Letter: **ST-010-2019**

Subject: **INTERFERENCE ON SSE BOARDS THRU THE SA BUS WIRES**

Product: Commercial

Summary: Field adjustments to the SA Bus Wire

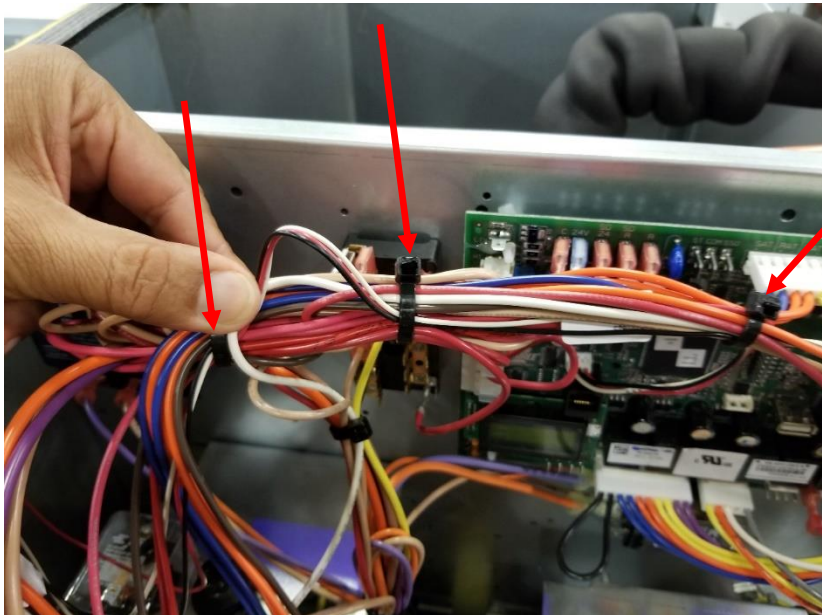
1. If you are experiencing weird symbols on your SSE Control board during operation or startup, you may be experiencing interference from high voltage being tied to the SA bus wire.

- a) Ensure power has been removed from the unit and you are wearing the required Personal Protective Equipment (PPE).
- b) Carefully remove all zip ties from the SA Bus wire.

Predator Example

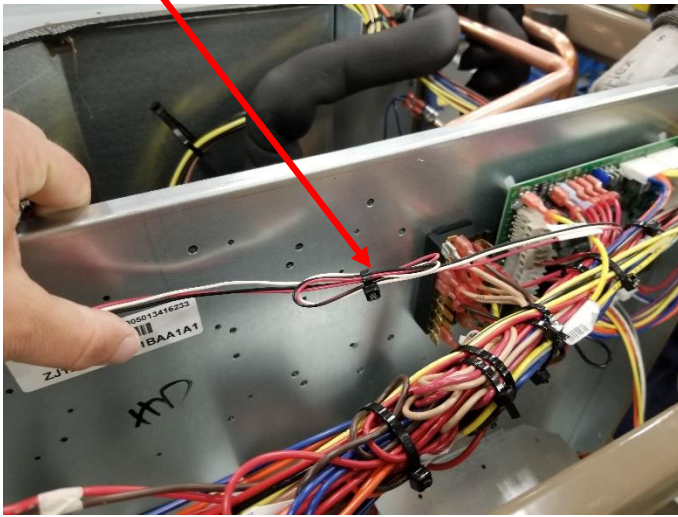
c) Zip tie the SA bus wires together. Ensure they are separate from other wires (see below).
